September 24, 2018

Re: East Lincoln Drive South Development Area; Smoke Tree Resort; Lincoln Medical Plaza
Effect on Adjacent Residential & Non-Residential Properties – Street Issues

September 5, 2018

Re: Paradise Valley East Lincoln Drive South Development Area Work Session – Sept. 13
 Major Special Use Permit Amendment (SUP-18-05) - Smoke Tree Resort
 Major Special Use Permit Amendment (SUP-18-06) - Lincoln Medical Plaza
 Effect on Adjacent Residential Properties

EXHIBIT B

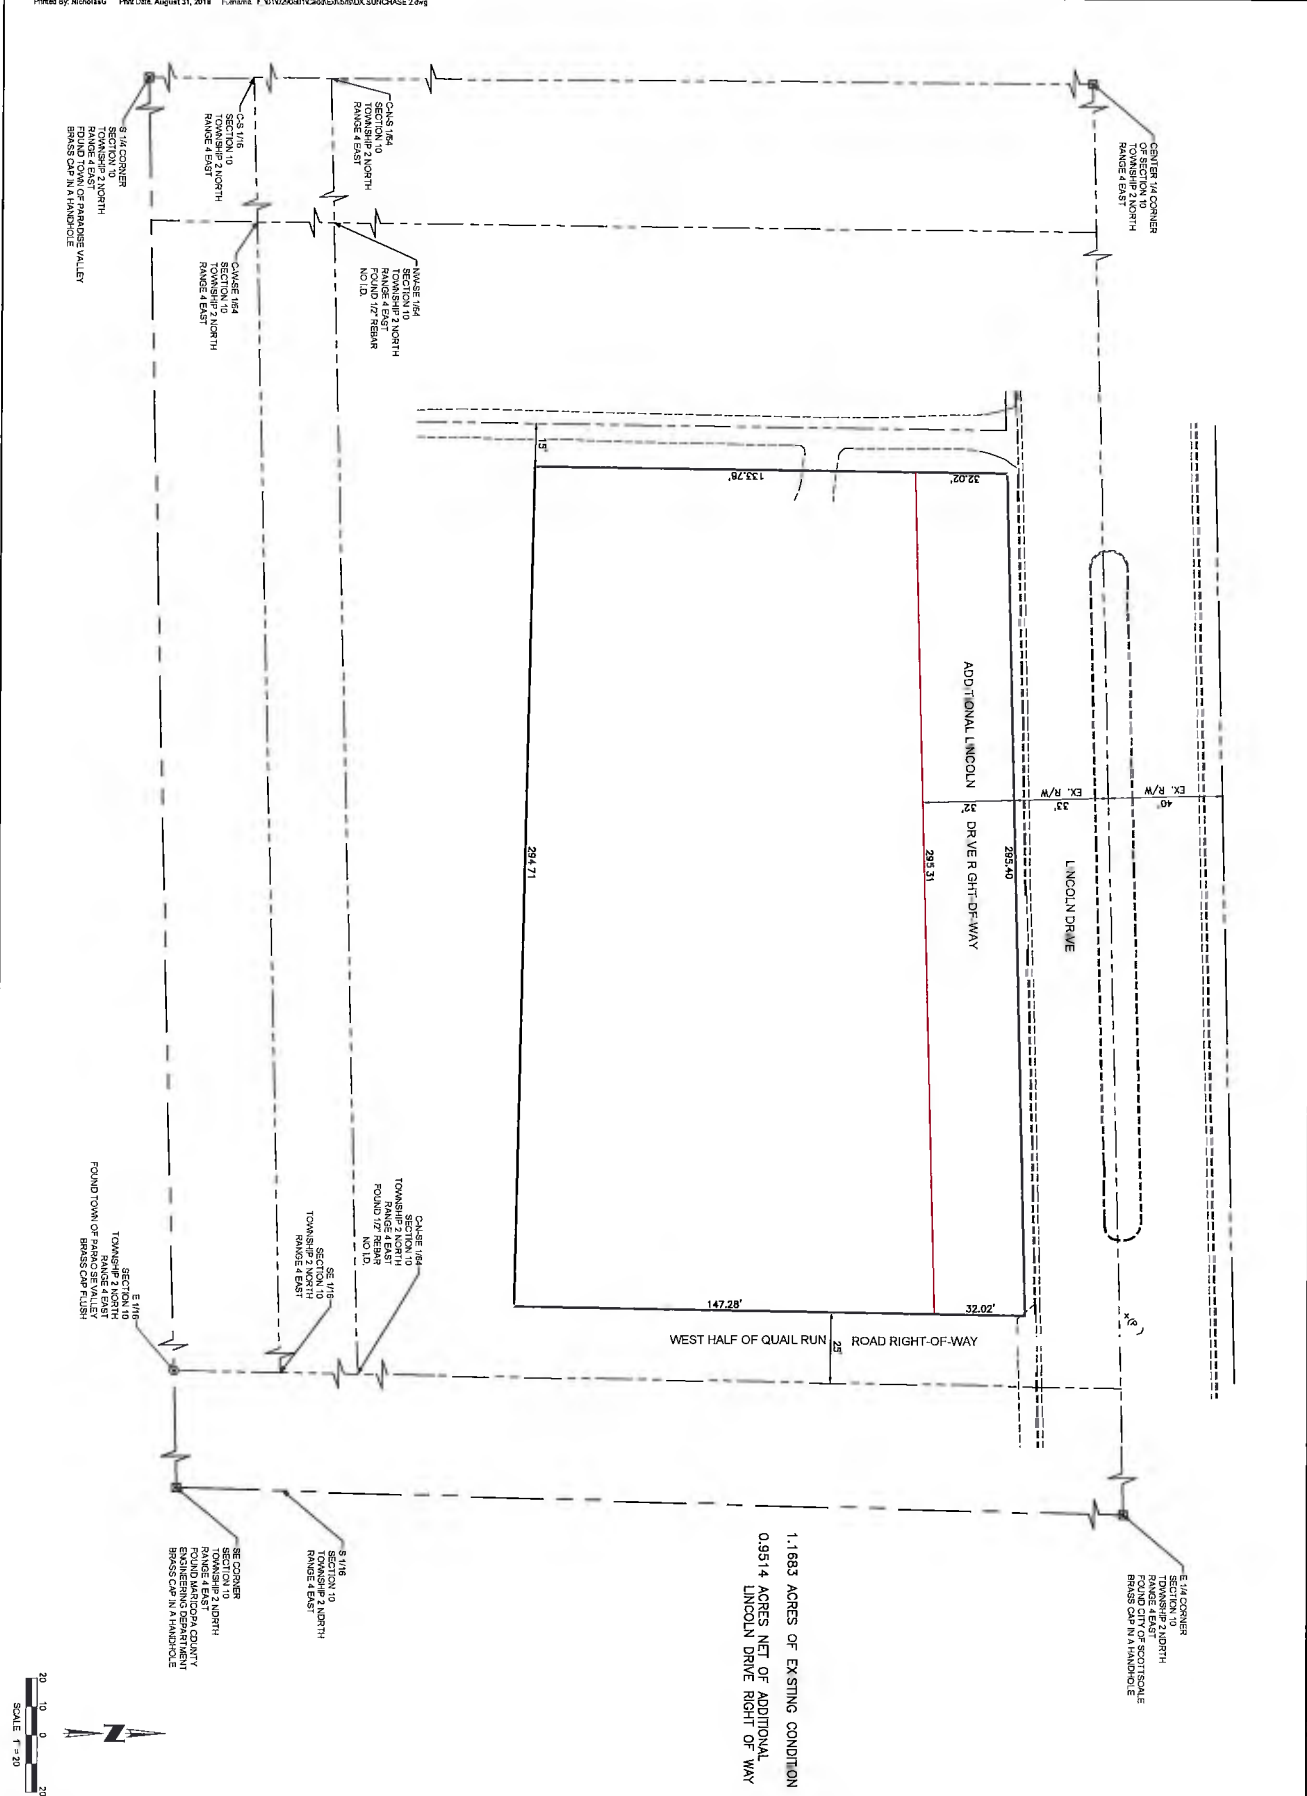
It's understood that Smoke Tree has resisted proposed changes to the existing access points and dedicating anything for streets as effectively shrinking the developable area of its property. In contrast, please see the diagrams attached as Exhibit B and Exhibit C and consider the impact on the neighboring residential property. Exhibit B depicts the current setback situation on the SunChase lot at the southwest corner of Lincoln and Quail Run. That lot is currently improved with a single-family home that is set back 52 feet from the existing Lincoln right-of-way. Exhibit C then depicts how the developable area of that lot is reduced by a number of potential additional setbacks that would impact any new construction. (1) The currently proposed Lincoln widening is an additional 32 feet (20 feet from the current residence). (2) Depending upon whether a new residence faced Lincoln or Quail Run, the front or side yard setback would be at least 40 feet from the widened Lincoln. (3) In either orientation, there is a recorded 50 feet setback required from Quail Run. (4) And in either orientation, there is another 40 feet setback from the rear and a 20 feet setback on the remaining side. (5) After the above points 1-4, the developable area that is left could be approximately $\frac{1}{3}$ acre, for an R43 zoned lot. Now, consider the exacerbating effect that along with Smoke Tree's proposal to further burden the half-street Quail Run, but not to dedicate its 25 feet, and to improve its property within that non-dedication area, it proposes to add two access points there. So, again, SunChase would like to know what the Town can do and proposes to do to address or otherwise protect the existing residential neighborhood adjacent to Smoke Tree.
